BOULDER COUNTRY CLUB

Swimming Pool Audit

Counsilman • Hunsaker
AQUATICS FOR LIFE

November 2020

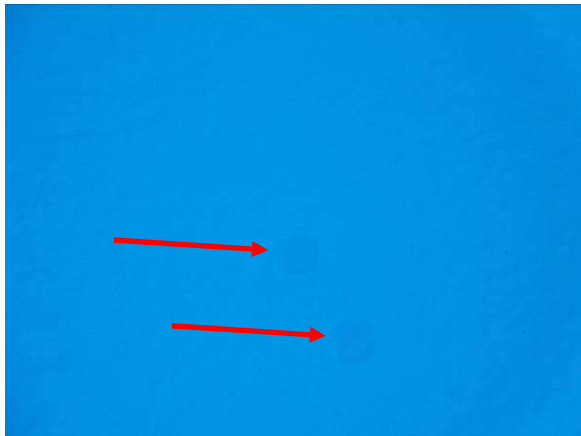
A Renosys PVC Pool Membrane liner is used at the lap pool, and it was installed in 2003. The liner is showing its age, and it is quickly approaching the end of its useful life. Many patches can be seen around the pool, and bubbling is occurring which means water is getting beneath the liner.

The sealant at the expansion joint of the pool is in fair condition.

Replace the aging liner at the lap pool.

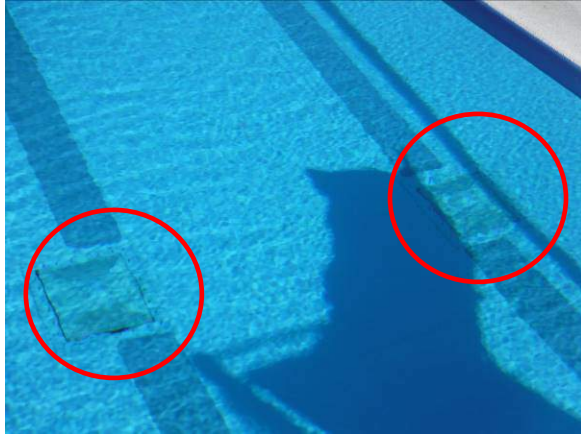
A perimeter overflow or skimmer system is not provided for the wading pool. Proper surface skimming of the pool water is not completed as required by administrative code.

In conjunction with a pool replacement, replace the perimeter overflow system in its entirety at both pools.

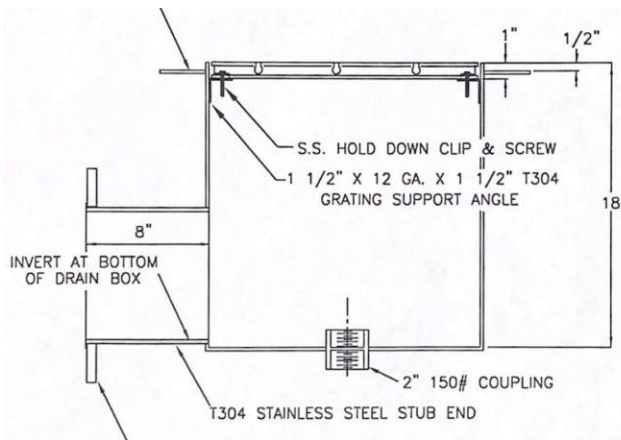
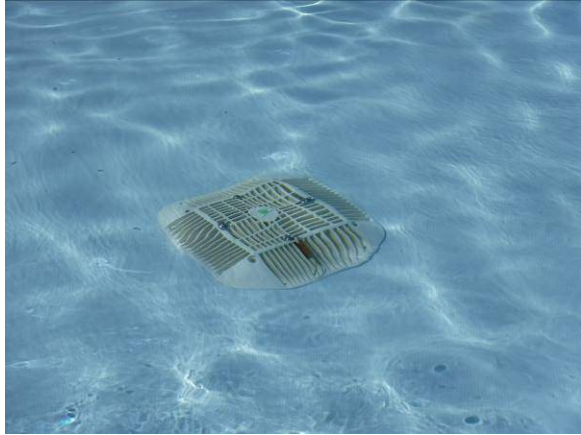
The sumps, however, are not certified VGB compliant and were installed prior to VGB being enacted by the Federal Government. 1.5 suction pipe diameters must be provided between the top of the suction pipe within the sump and the bottom of the grating covering the sump. In this case the suction pipe is 8", and the required 1.5 diameter dimension of 12" is not met.

At the time of the visit, it could not be confirmed that the hydrostatic relief valves located within the sumps are operational – staff to confirm.

Confirm that existing hydrostatic relief valves are in-place and operational.

Increase the depth of the drain sumps in the lap pool to meet VGB compliance.

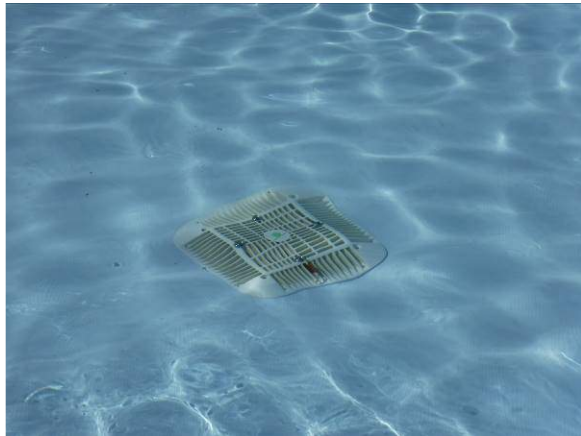
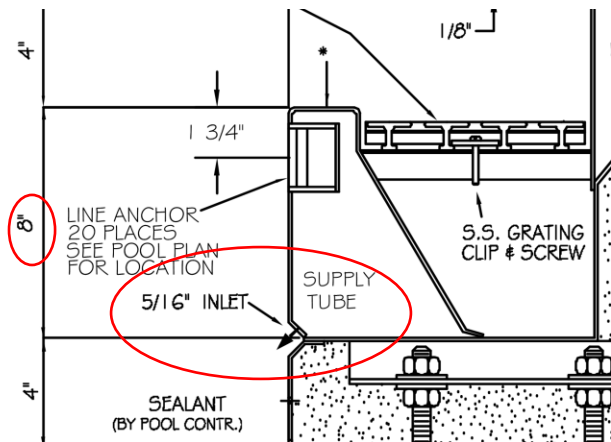
The suction outlet located within the wing wall is an abnormally sized metallic grating. This outlet is not considered VGB compliant. However, since two (2) other suction outlets exist in each individual pool area, the pool would still be considered VGB compliant if this wing wall outlet was removed.

Disconnect piping to the wing wall suction outlet in the wading pool, or plug the suction outlet entirely.

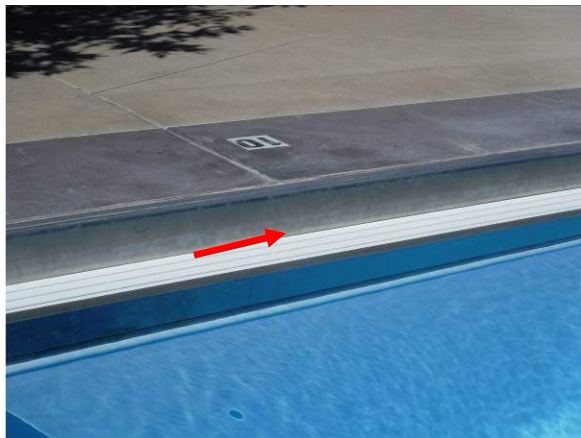
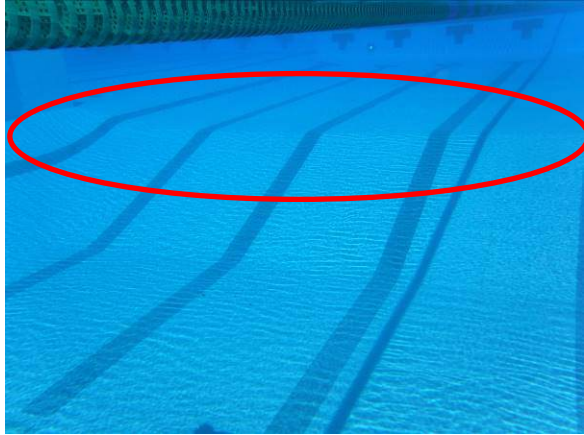
However, depth markers are not located at the slope break to the deep end as required by MAHC. Some depth markers are only present on the deck and not on the vertical wall of the pool, which violates code. All of the markers do not have “FT” and “IN” designations in 4” height as required by MAHC; and text for the “No Diving” signage must be 4” in height as well. “No Diving” signage must be provided with all depth markers (vertical and horizontal) for all pool depths 5’ and shallower.

The pool does not include a contrasting 4” band at the 5’ water depth moving towards the deep end, and cup anchors are not supplied for a safety rope which is required by administrative code. Contrasting floor markers and wall targets for lap swimming were installed in 2013 according to staff. They are discoloring, and some are beginning to peel away from the pool liner.

Add a 4” width contrasting band at the 5’ water depth drop-off at the lap pool. Provide a safety rope with this contrasting band.

Add or modify depth markers and “No Diving” signage to meet all applicable codes.

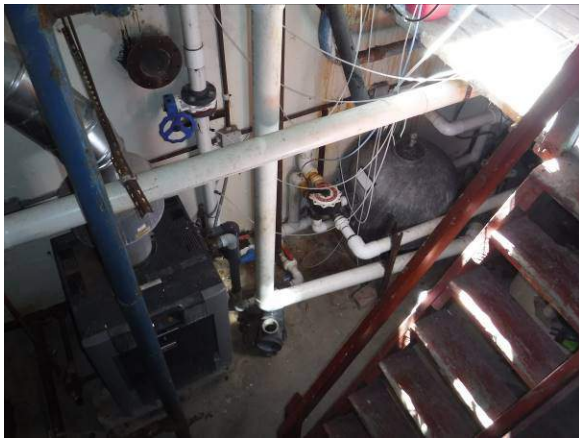
Various piping is undersized and exceeds the maximum velocity requirements set forth by code. This piping includes: the filter backwash line, supply line back to the pool inlets, gutter drain converter lines, and pump discharge piping. A set of unnecessary 4" pressure piping is provided on the discharge side of the pump. In some areas there are erratic fittings or changes in pipe sizes.

All metallic valves show signs of corrosion. Valves are not tagged and labeled per MAHC.

An impact flow meter is provided downstream of the filters; it is not operating correctly, and it is not installed according to manufacturer instructions. Aquatics industry standard calls for the installation of a Signet Magmeter to accurately measure flow rate, and connecting this to the chemical controller and/or recirculation pump VFD (if included).

Replace all pool piping, fittings, and valves with Schedule 80 PVC material. Ensure that all piping is properly supported with epoxy-coated galvanized steel supports and labeled with color-coded directional flow arrows. Remove all unnecessary piping.

Provide tags for all valves in accordance with MAHC. In conjunction with a major pool replacement/renovation, install a Signet Magmeter on each pool recirculation system for accurate flow readings.

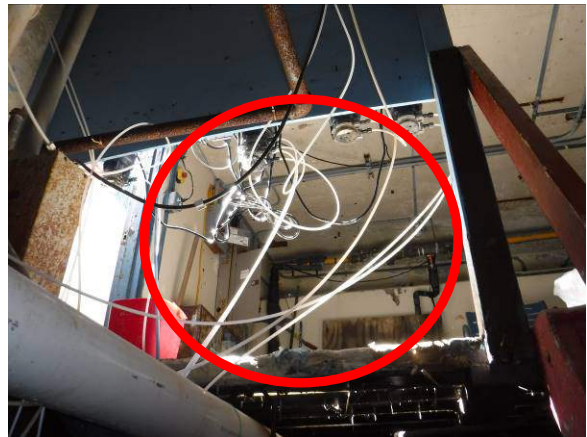
However, MAHC requires that any wading pool be equipped with a secondary disinfection system, which was not observed. An example of secondary disinfection is an Ultraviolet System.

Encase all poly feed tubing in Schedule 80 PVC Pipe in order to prevent any damage or leaks to the piping.

In conjunction with any major pool replacement/renovation, provide a UV system for the wading pool. Additionally, provide new chemistry controllers for both pools that have the capability for connection with flow meter sensors and Fireman Cycle features.

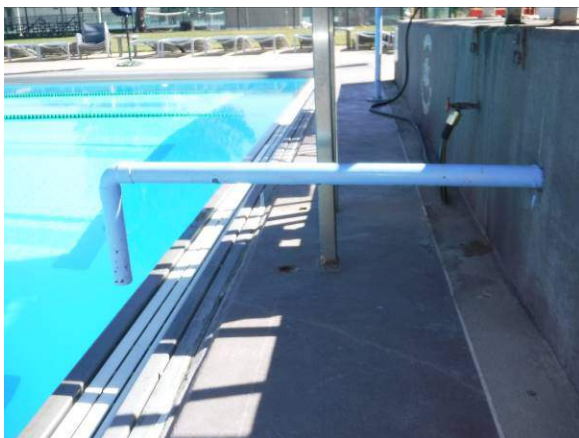
Make up water is manually added to the lap pool via the water supply which can be accessed with valves that are located within the mechanical room space. The water flows and drops into the pool directly underneath the springboard via an air gap, in accordance with administrative code. Valves and piping used for this system show their age and require replacement soon.

In conjunction with a major pool replacement, provide water level control systems for both pools. An automatic makeup water system is required by Model Aquatic Health Code (MAHC) for the lap pool. However, installation of a system is recommended for both pools. This includes solenoid valves, sensors, and water level controller for each body of water. Lap Pool make-up water could be supplied within the surge tank, and make-up water for the Wading Pool could be supplied via direct fill on the suction side of the recirculation pump with an approved backflow prevention device.

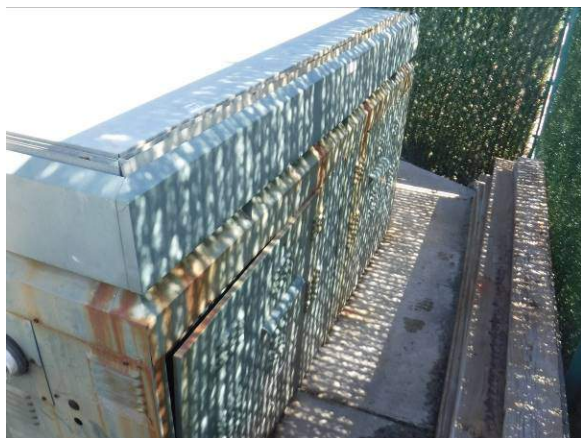
Natural gas could be smelled around the heater at the time of the audit visit. Staff reports that minor gas leaks have been an issue previously; if leaks are still prevalent, this could be causing performance issues with the heater.

Influent and effluent heater lines are a Schedule 40 PVC material, and the water connections have some staining present.

Provide a new high-efficiency heating system at the lap pool that is suited for outdoors, high altitude, and shoulder-season use. Install the new lap pool heating system with CPVC influent/effluent piping.
